Deadline 7 Submission on Behalf of the Neighbours and Users of Queen Elizabeth Park

Interested Party reference no: **20022545**

1. Summary of Our Position

Corrected tree positions: T562 (sycamore), T487 (beech) and T489 (beech) are not correctly located on Esso's map. Dotted orange lines show the position on Esso's tree survey, solid orange lines show roughly where the trees actually are.

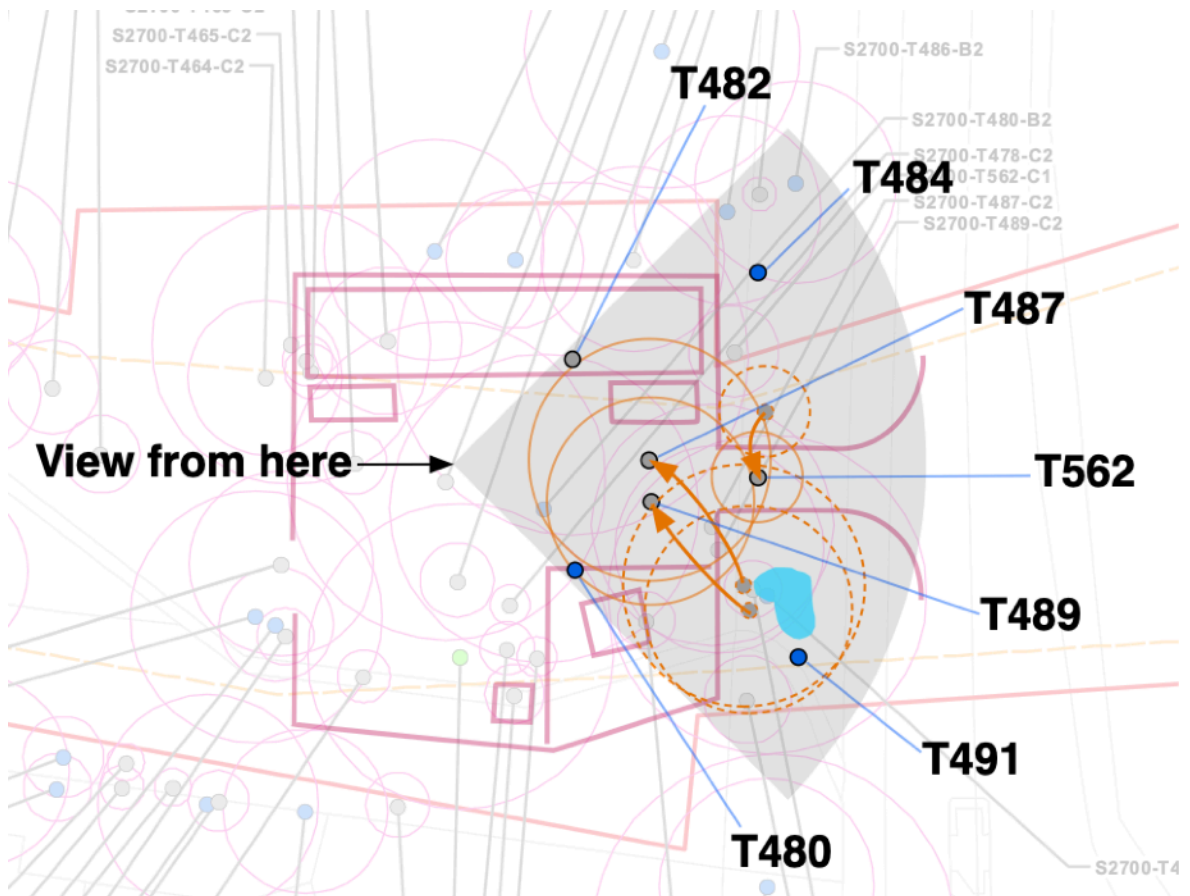
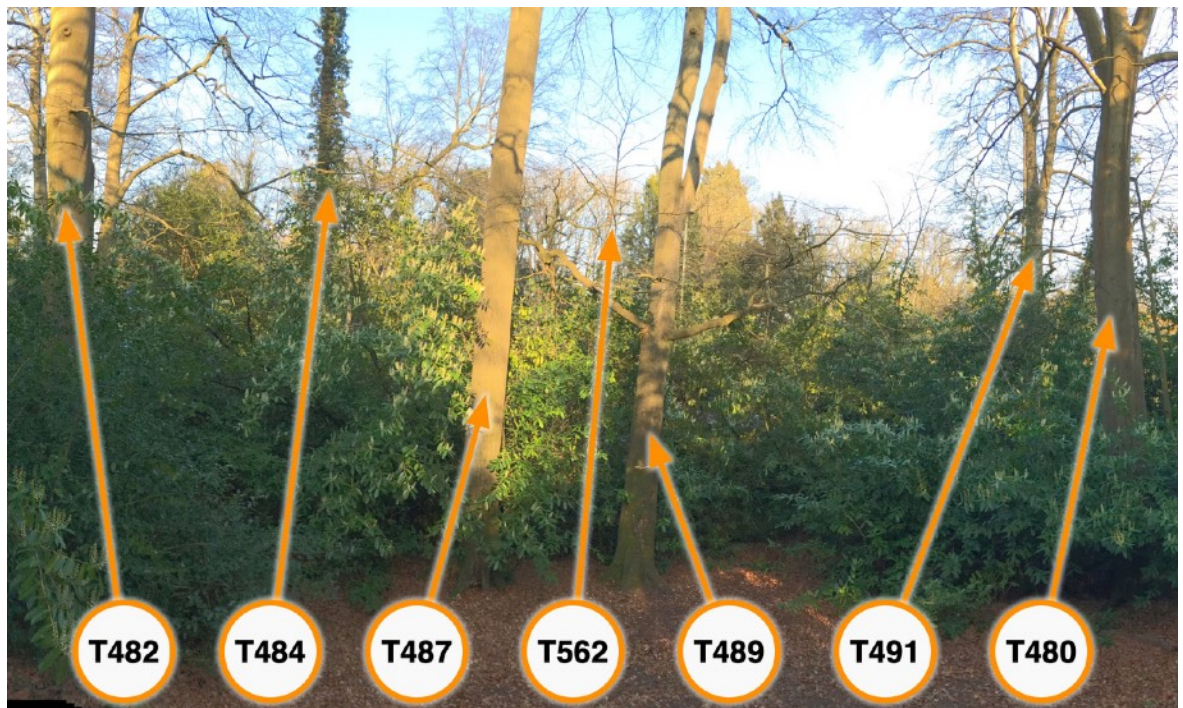
We have concluded that some trees are not shown in the correct place, namely T487, T489 and T562. As evidence of this, we present a photograph taken from a known point, with trees from Esso's survey labelled. It should be evident that Esso's plan cannot possibly be an accurate representation of this view because if it were, T487, T489 would appear almost in line with T491.

Our amendments to the drawing show the more likely positions of these trees. We note that all three trees would obstruct the proposed entrance and access ramp for the compound.

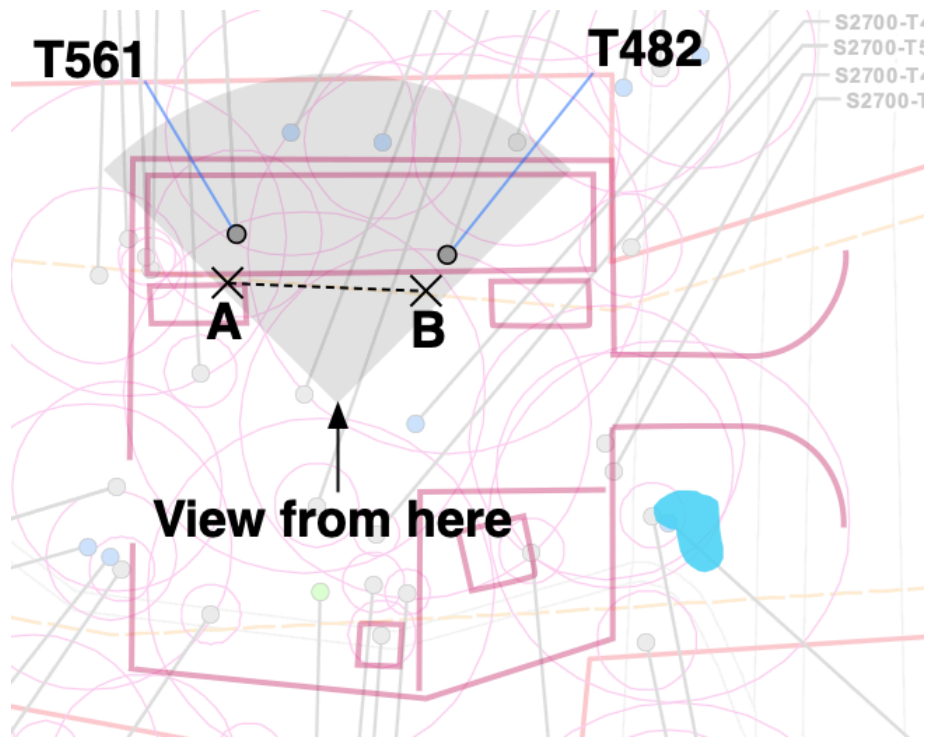
The drawing and photograph below attempt to give an impression of the gradients within the proposed auger boring compound. The photograph shows the difference in ground levels between points A and B in the plan. This is by no means the steepest gradient in the area but it is the easiest to photograph. The gradient between these points is approximately 24% but there are areas with gradients of 35% and more.

It would have been useful if Esso had submitted a topographical survey of the area to the examination to show that their plans are feasible. In the absence of this information, and with our knowledge of the site, we conclude that the survey has not been provided because it would prove that Esso's plans for this area, with the stated level of tree retention, are not feasible.

3.6. Auger Bore Pit Location

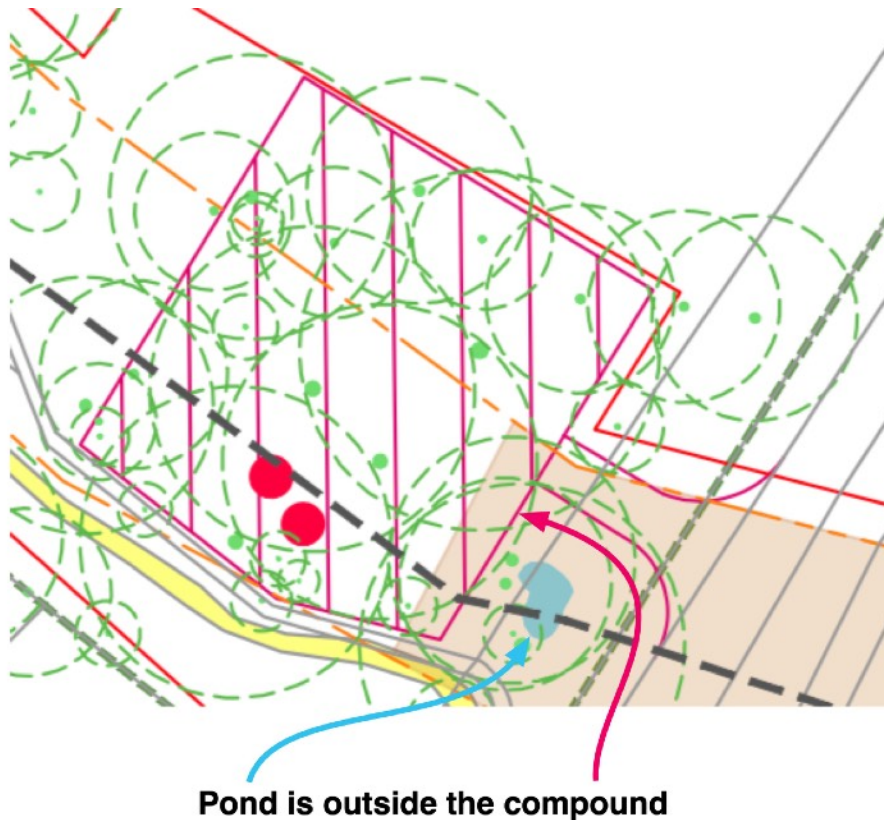
Note that the pond (blue area) is outside the pink hatched area which the key describes as ‘area for auger boring activities’. This means that the pit would be outside the compound and therefore not protected by being enclosed by it. Furthermore, the compound fencing would prevent machinery from accessing the pit area.

The reasons for enclosing such a large area within the compound, when gradients and tree cover mean it cannot be used for any activities, are unclear. There is no explanation as to why the pit is outside the compound.

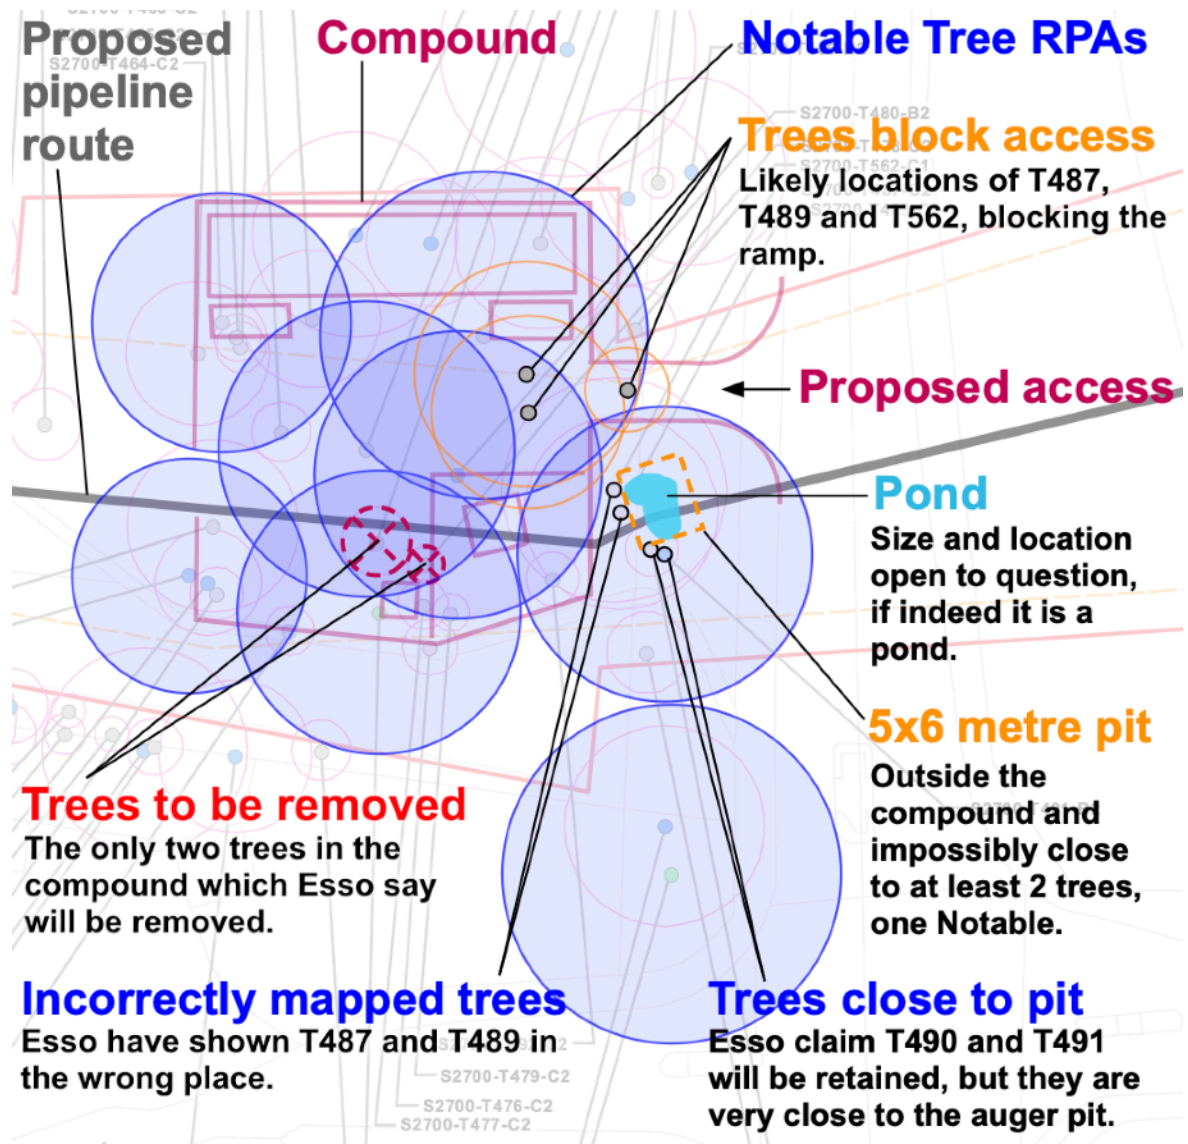
The entire area is still very badly thought out and poorly documented. The information presented by Esso to the Examination does not make sense.

The diagram above is based on the tree survey drawings in the QEP SSP and attempts to show some of the main issues with the plans and proposals provided by Esso.

Trees or pond are incorrectly positioned in the drawing

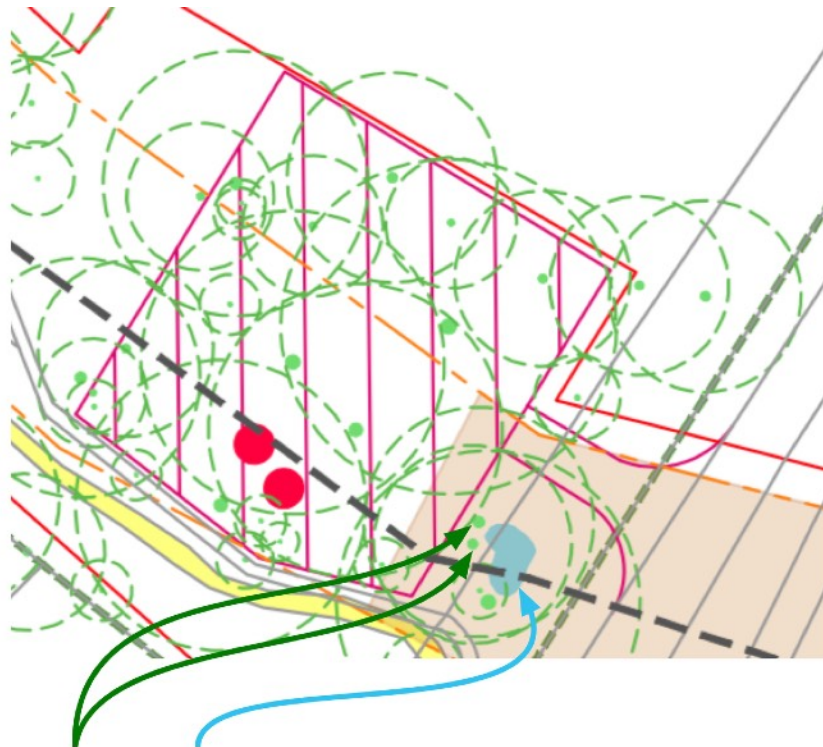
The construction phase drawing in the SSP (extract below) shows the water body/ depression adjacent to T487 and T489 (unlabelled on this drawing but numbers are obtained from the tree survey drawings):

Standing on site and checking this visually, there is no depression or pond adjacent to T487 and T498. Based on this, we believe that not only are the trees drawn in the wrong location (see section 2.2), but the pond/depression is also drawn in the wrong location.

The distinctive oak leaf shape can be seen in the magnifications

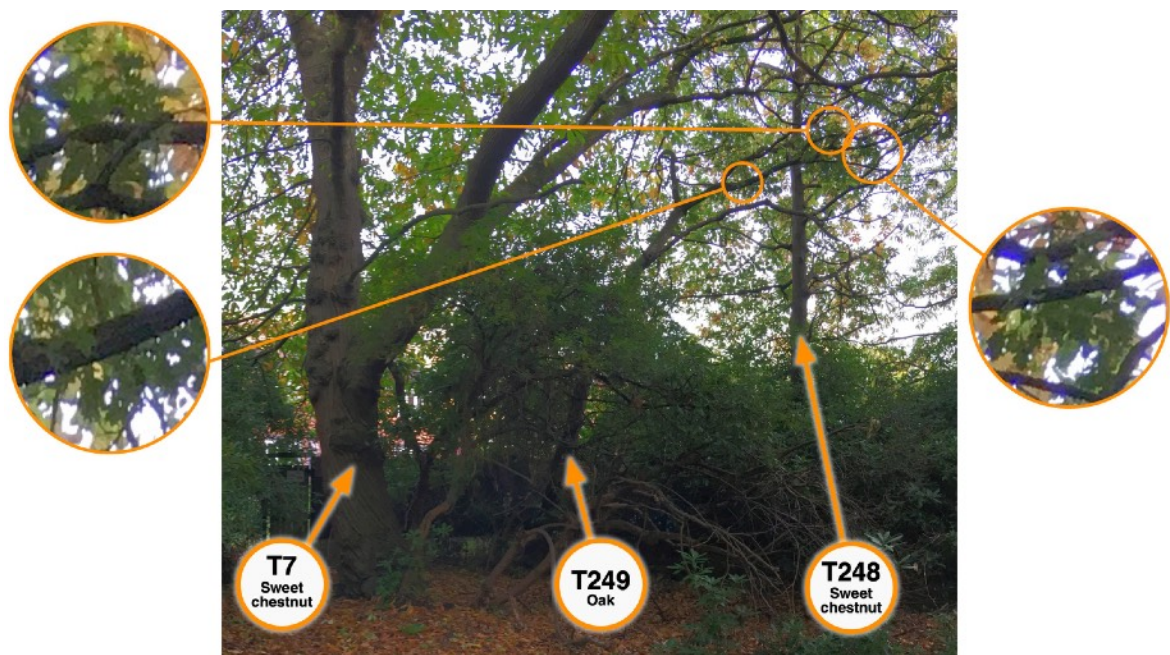
It is difficult to know how best to respond to this. We are extremely familiar with this area of the park. We have also studied Esso's tree survey and drawings in detail to make absolutely certain that we are confident in this assertion: T249 is an Oak.

The photograph below is the only recent picture we can find of T249 when it is in leaf and therefore provably an oak. It was taken in October 2018. We have done the best we can to highlight identifiable oak leaves in the picture but are limited by the low resolution of the picture.

4.6. Page 79, WR Para 2.1.3: Trees Identified for Removal

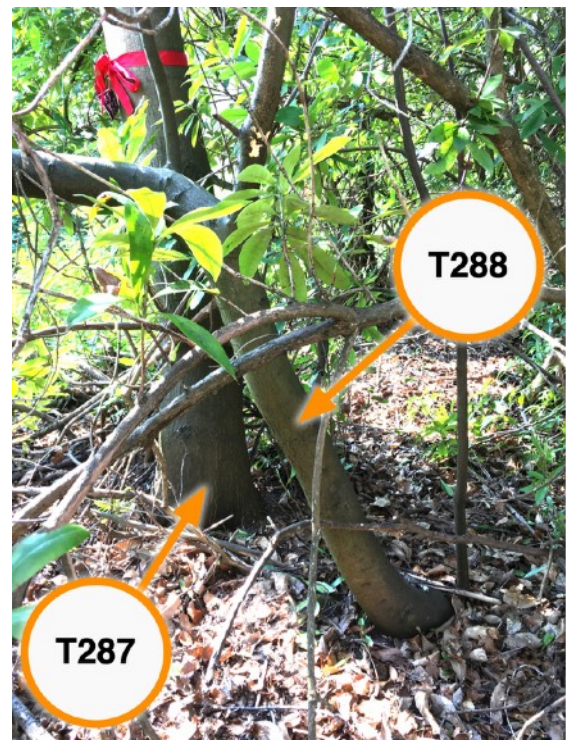
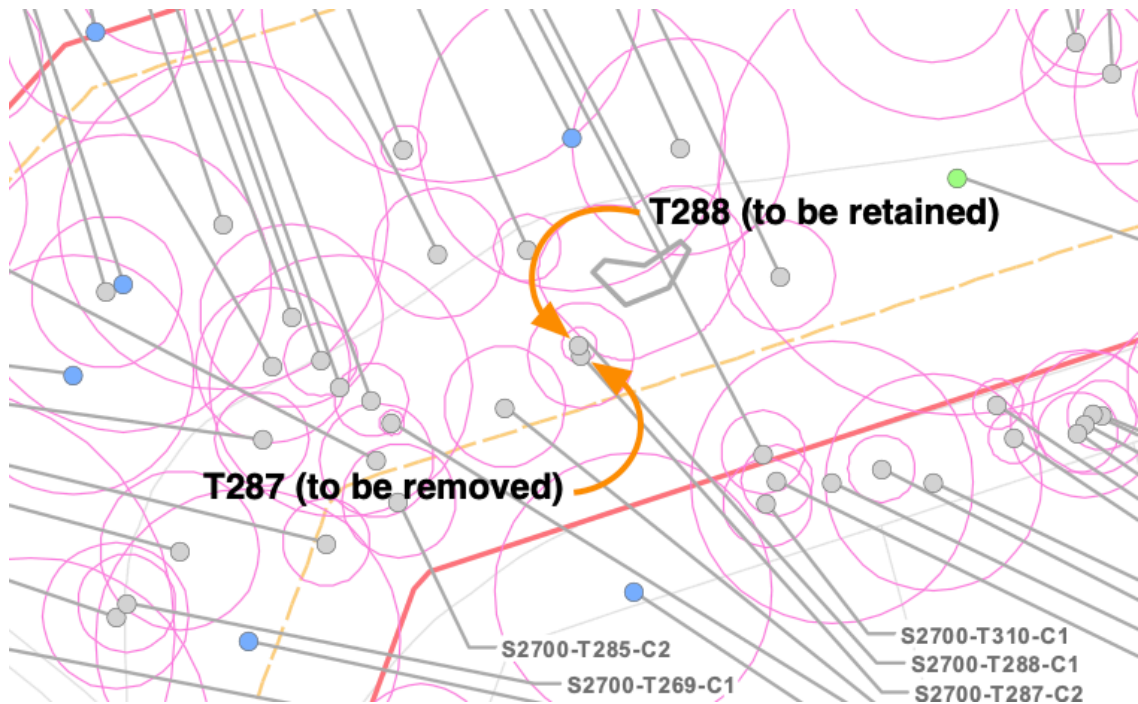
We clearly stated within our submission, that due to the fact that Esso did not provide a list of trees which would be removed, identified by their survey number, we had to deduce this from the tiny red dots on their small scale plans, many of which were overlapping and unclear. We even highlighted two of those trees with a '?' in our table to declare our uncertainty. We were not trying to claim more trees or embellish the truth.

We have doubts about Esso's ability to state so confidently that only those trees which they have listed will be removed. We can show that trees which they claim will be retained are likely to suffer serious damage when their neighbours are removed.

For example, we are somewhat surprised that Esso believe T288 can be retained and not damaged by any works which necessitate the removal of T287 given its proximity to T287. The diagram and photographs below show why this seems hard to believe and leads us to question the commitment on 30 trees.
